**CORPORATION OF THE CITY OF COURTENAY
COUNCIL MEETING AGENDA**

To: Council
From: Chief Administrative Officer
Subject: Development Permit with Variances for 1978 Cliffe Avenue

File No.: 3060-20-1401
Date: December 14, 2015

**Subject: Amendment to Development Permit with Variances DP#1401
1978 Cliffe Ave – Proposed Mixed Use “Riverwalk” Development**

MAIN FLOOR PLAN
 1/8" = 1'-0"

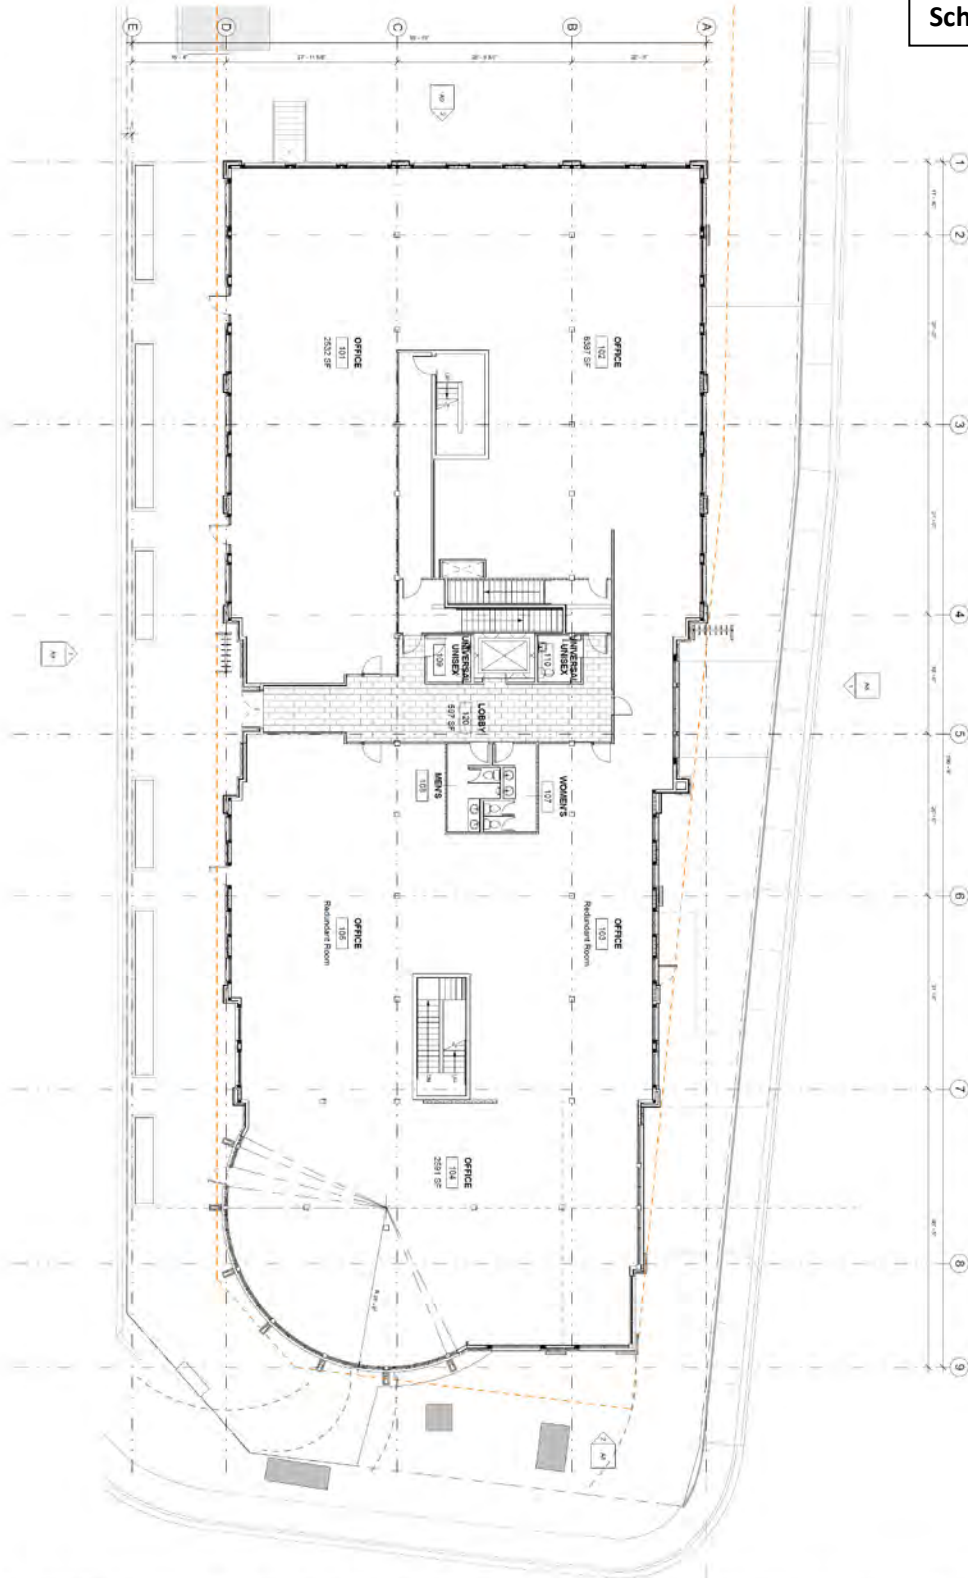
- The parkade plan has been revised to incorporate stairs, exiting changes and now includes an amenity area for shared residents use.
- The main floor plan has been revised to incorporate stair changes for second floor exiting.

SECOND FLOOR PLAN
 1/8" = 1'-0"

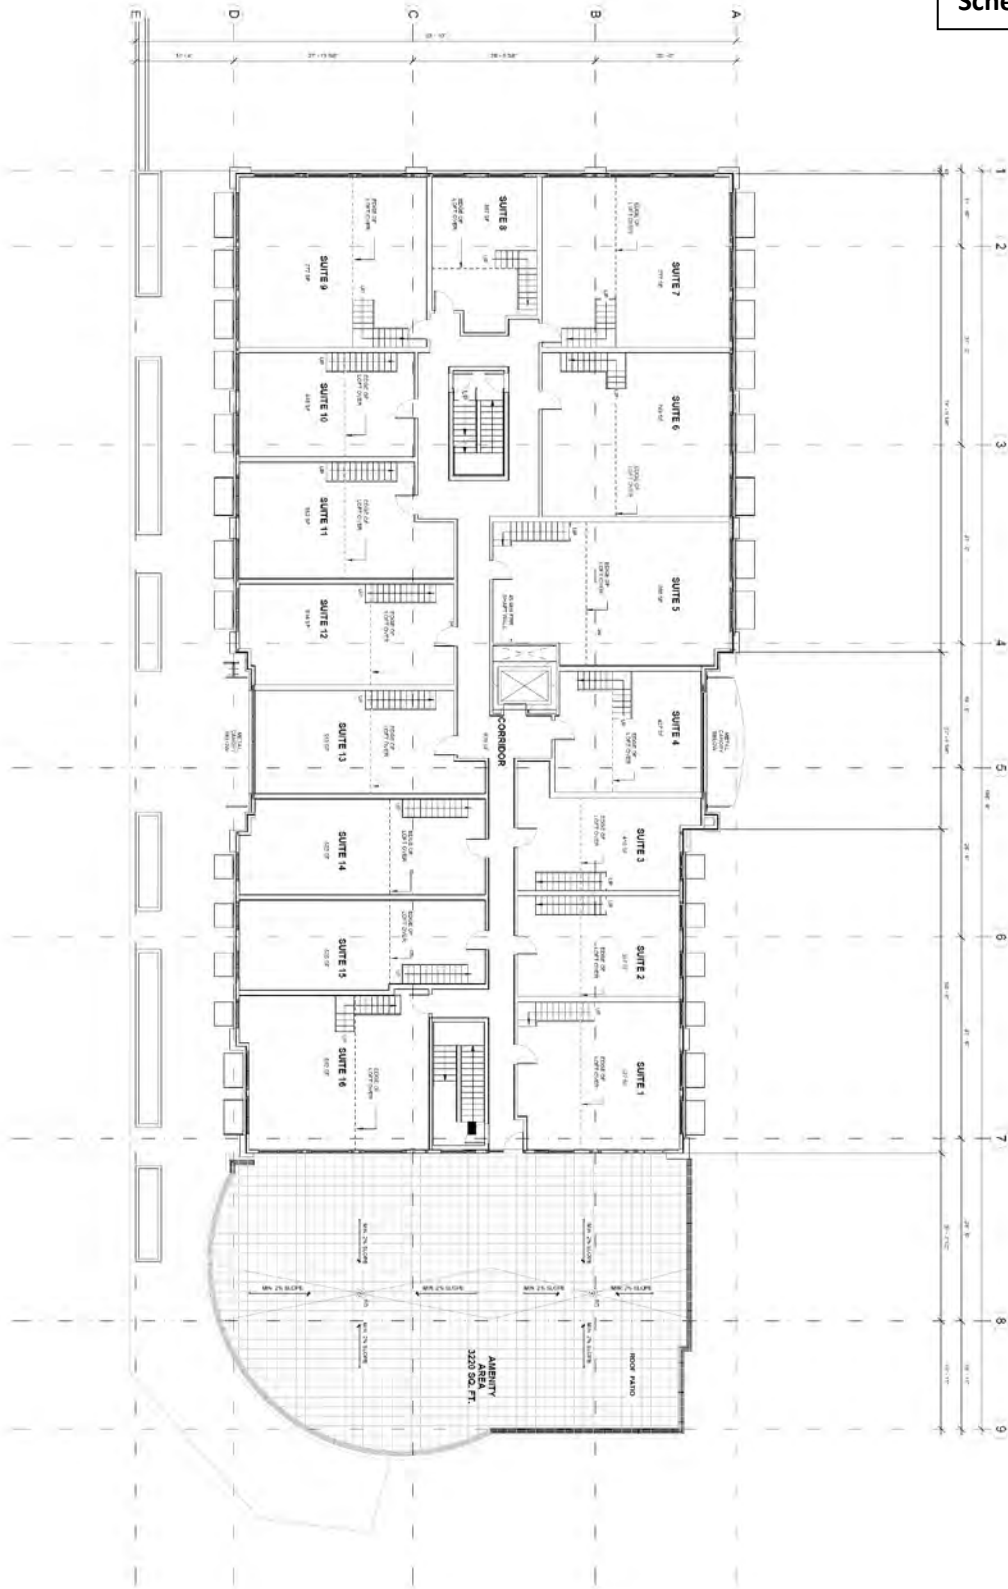
- Suites with lofts have been added to the second floor plan and loft plans have been added which also incorporates the mechanical and electrical room. The roof patio has been enlarged for shared resident use and the required usable open space.

CONSULTANT: **A8** BUILDING ELEVATIONS

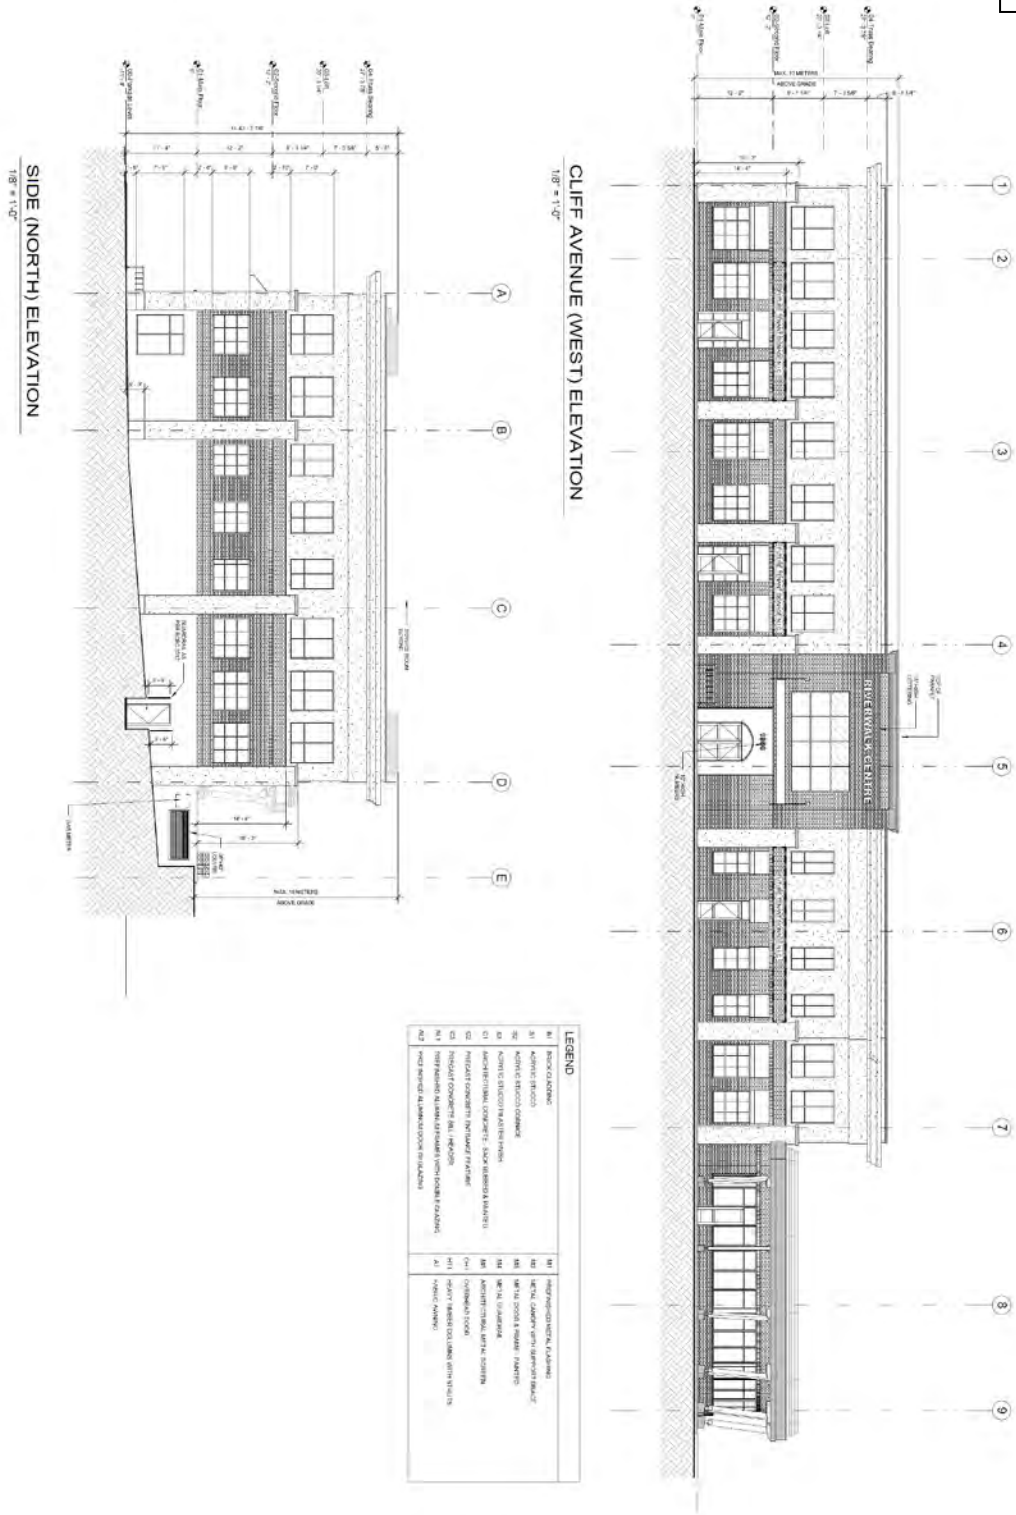
- The building sections have been updated accordingly.
- Building height changes as noted on the plans, to a maximum of 10m. The mechanical raised roof has been deleted and the entire roof has been raised to accommodate the lofts.

- A new color change band has been added along the top of the exterior walls below the parapet. The purpose is to add visual interest to the uppermost perimeter wall.

- The raised windows flanking the ends to the second floor have been modified as shown, otherwise windows are unchanged.
- The parking and amenity project data has been updated on the Site Plan.
